Re: Verizon Permit Application for Small Cell Installation

110 Howland Avenue (Parcel ID #6054-14-34746460-3-14.1)

City of Beacon, New York, 12508 Verizon Site Name: Howland Micro

Technical Review Memo

Feb 6, 2019 photo of area behind the proposed facility. Note topography increase in grassed area and presence of drainage swale.

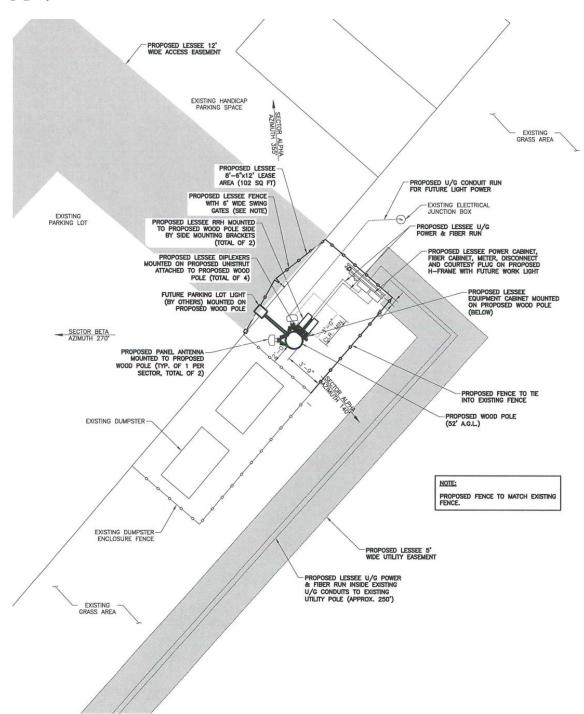
- The Drawing set (e.g., DWG Z-1) should be updated to show all property lines for the subject site, including the back property line. PROVIDED property lines were added. HDR's site visit noted a drainage swale on the slope behind the parking area with a sign marked "Private Property". It is requested that Verizon confirm if any subgrade utilities or easements may be associated with this feature. Information on subgrade utilities not provided. The updated drawings provided by the applicant depict a 5 ft wide utility easement, which is for an underground power and fiber run to an existing utility pole, located about 250 ft away. Photos of the area behind the proposed compound, including the drainage swale, are included earlier in this Tech Memo.

Photosimulations of proposed Verizon installation at 110 Howland Avenue

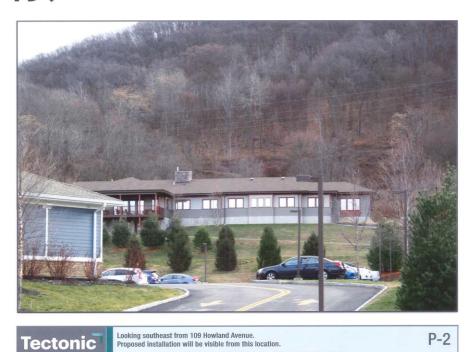
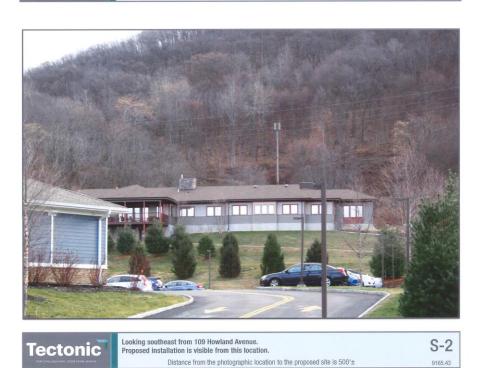
- The proposed antennas, mounting structures and cable runs shall be color matched to the pole and in accordance with the photosimulations provided for this application. A matte finish is recommended for all proposed equipment. For the ground-based equipment fencing, a white color and texture to match the existing fencing at the site (see above photos) is recommended. The height of the fencing (all 4 sides) shall be consistent with the existing fencing off the parking lot, and HDR recommends it be no shorter than the height of the RRH units depicted on the cross-section Drawing (approx. 7 8 ft). The proposed fencing shall comply with Section 223-13.G, unless the Building Inspector determines that this Section does not apply and a taller fence is permitted around the small cell pole and equipment. If approved, the height of the small cell fencing would be greater than the adjacent existing fencing (approx. 5 ft), but the additional height (and signage) would serve to deter trespassing.

Cross-section view of proposed 110 Howland Avenue wireless telecommunications facility

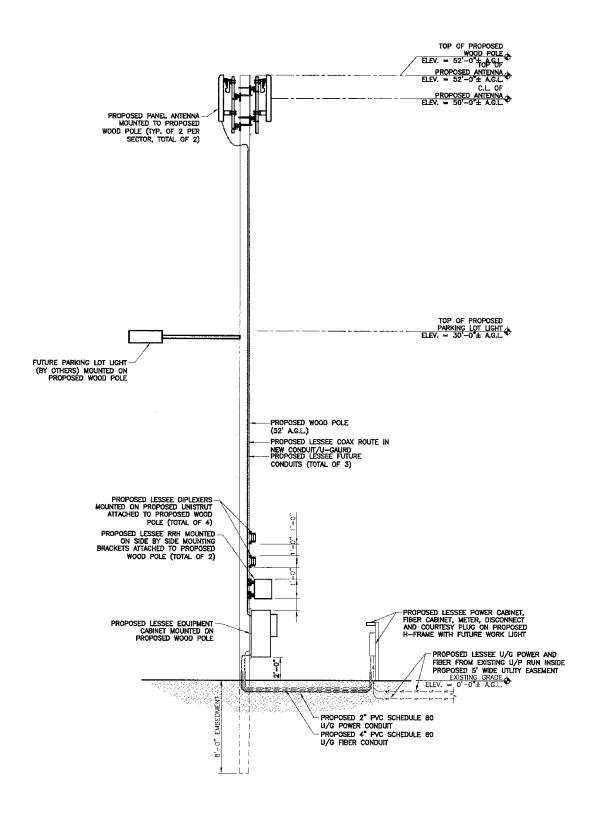
- If the Special Permit is approved, a structural and foundation analysis shall be provided as part of the future Building Permit application. It is understood that no guy-wires or exterior supports are proposed. The analysis should also account for a possible parking lot lighting fixture (depicted on the Drawings). Any lighting proposed or planned shall first be approved by the City Building Department. No lighting is proposed or required as part of Verizon's small cell application.

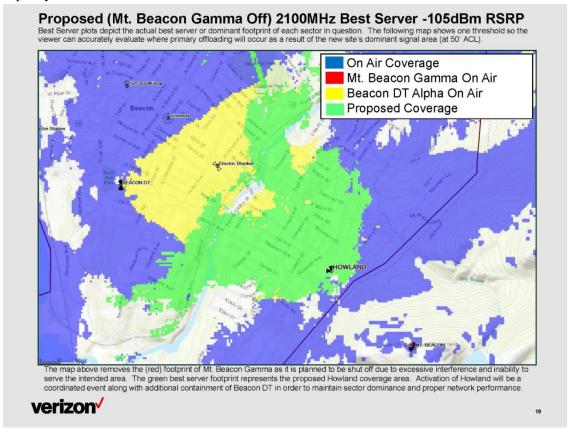
The below map (2100 MHz) provides a similar area scale, and includes signal modeling for the proposed small cell. The green area below indicates coverage and capacity for the 'open space' signal, which can be compared with the orange color in the above map. New and supplemental service has adequately been depicted. The application materials also include capacity trends from the existing macro cell sites Beacon DT

## **Supplemental: Height Justification**

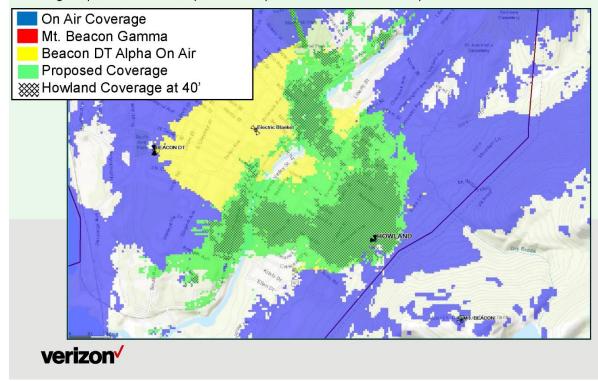
Lowering the antenna centerline from 50' to 40' causes unacceptable loss of sector dominance as well as weaker signal strength throughout the intended coverage area which would result with compromised offload and coverage capabilities. The comparison of expected dominant sector footprints is shown below.

Necessity Case. With this information, the alternate height evaluation appears to be complete and the proposed panel antenna and pole heights appear to be justified (see below discussion under Section 5).
